UTAH DEPARTMENT OF TRANSPORTATION

SUBJECT: Standards Committee Meeting Minutes and Next Meeting

Specification/Drawing/Item Title: Concrete Barrier/Pre-cast Constant Slope Concrete Barrier

Specification/Drawing Number: 02844/BA 3C

REINFORCEMENT FOR PRE-CAST
CONSTANT SLOPE CONCRETE BARRIER (TYPE 1)
SHOWING REINFORCEMENT FOR JOINT CONNECTION ON (TYPE X)

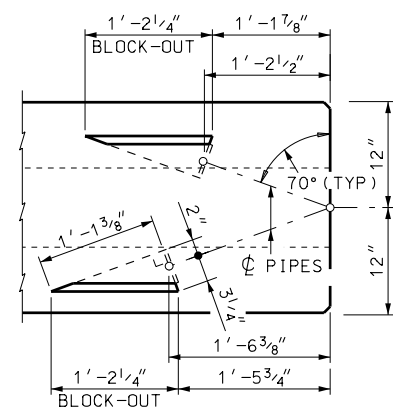
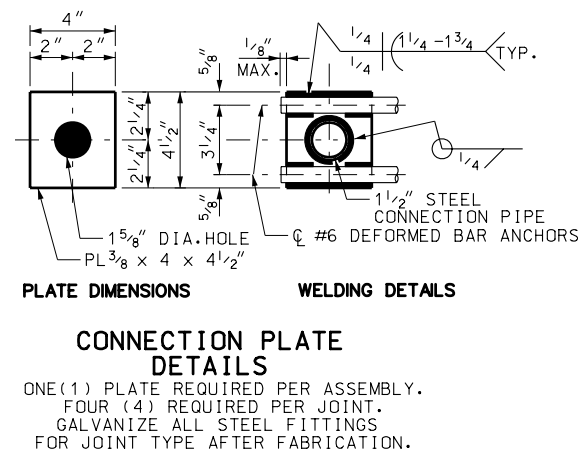
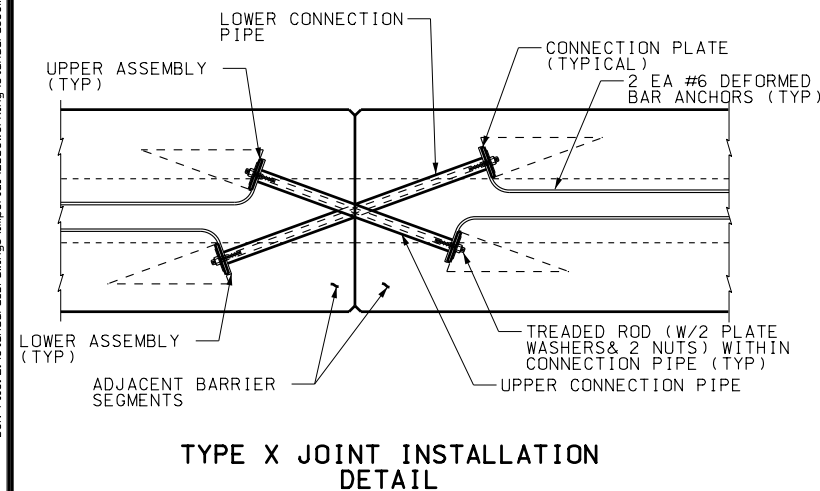
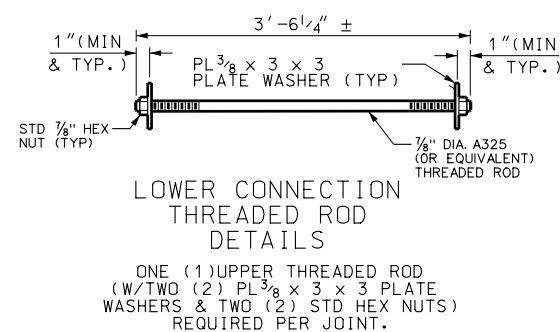
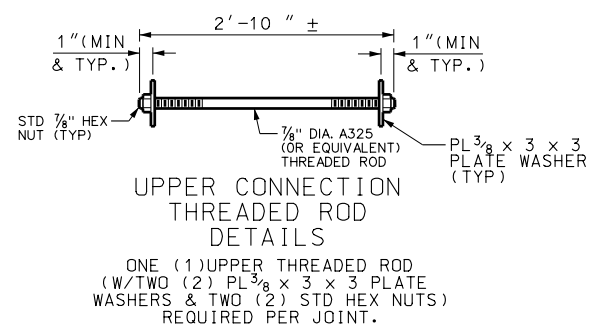
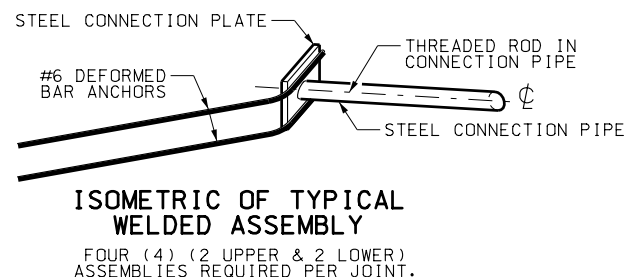
I am attaching a PDF copy of a red-lined BA Standard Drawing. Also, I received the following comments from Dan Church at PB regarding the new BA Standard Drawing:

- 1. Upper Connection Threaded Rod Details: Correct spelling of "Details"; Revise Dia. of A325 Rod to 7/8" to match nut.**
- 2. Lower Connection Threaded Rod Details: Revise "Upper" to "Lower"; Revise Dia. of A325 Rod to 7/8" to match nut.**

- 3. Connection Details: Place space between "After" and "Fabrication".**
- 4. Reinforcement for Precast Constant Slope Concrete Barrier (Type 1): Clarify 30'-0" \pm 1" dimension. Should it be 30'-0" \pm 1"?**

- 5. Barrier Plan At Joint: Add (Typ) to bottom orthogonal Leave-Out dimensions; "Block-Out" is the commonly used term for "Leave-Out".**
- 6. Deformed Bar Anchor Details: Use 3'-7" length instead of 3'-3" to fully develop bar strength per AASHTO requirements.**
